Lloyd's Register of Shipping.

Ship's Name S/S "HEDERA" Official No. 3578

Memorandum of alterations reported since ship was surveyed for assignment of Load Lines in

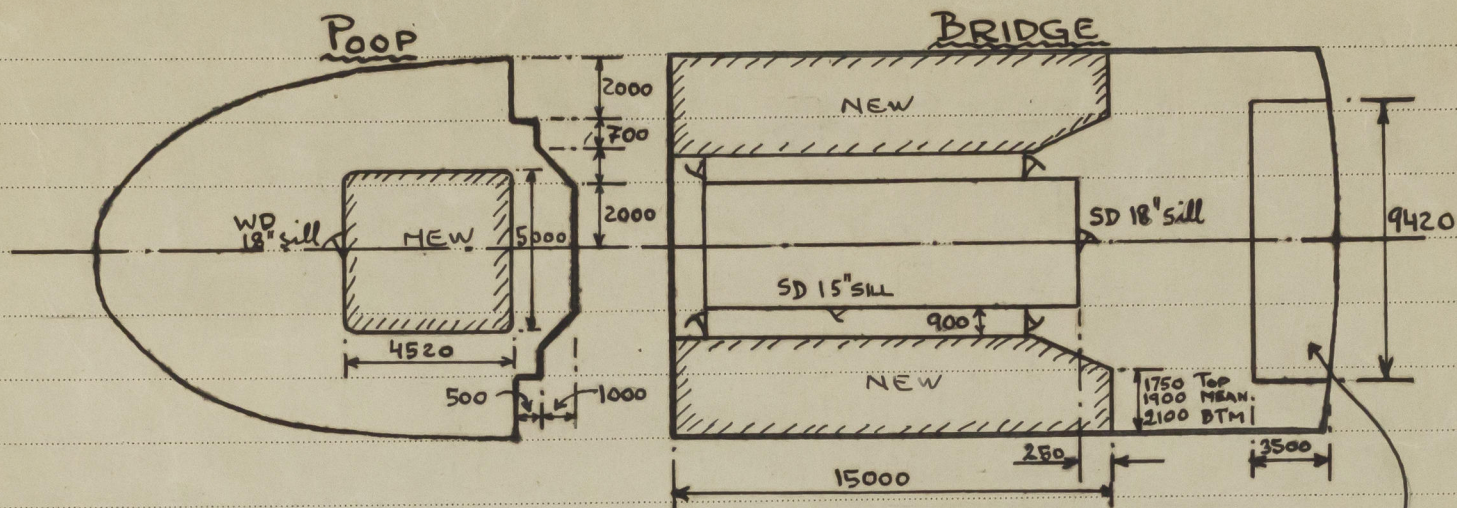
New Hatch Escape from after hold.

Opening = $800 \times 610 \times 9 \frac{m}{m}$
 Height = $850 \frac{m}{m}$
 Cover = $5 \frac{m}{m}$ (steel)
 4-3/4" toggles, closed WT.

Existing deckhouse but not reported on memo for report no 1142 (index no 14195) of the 21st July 1932 ✓

Opening in Bridge forward bulkhead has been placed nearer shell and has 42" sill now (starboard side).

New Poop Deckhouse:

L = $4520 \frac{m}{m}$
 B = $5000 \frac{m}{m}$
 H = $2200 \frac{m}{m}$

New Bridge Side Deckhouses:

L = $15000 \frac{m}{m}$
 B = $2900 \frac{m}{m}$ (mean value)
 H = $2200 \frac{m}{m}$

The Poop deck has received a recess or platform for winch.
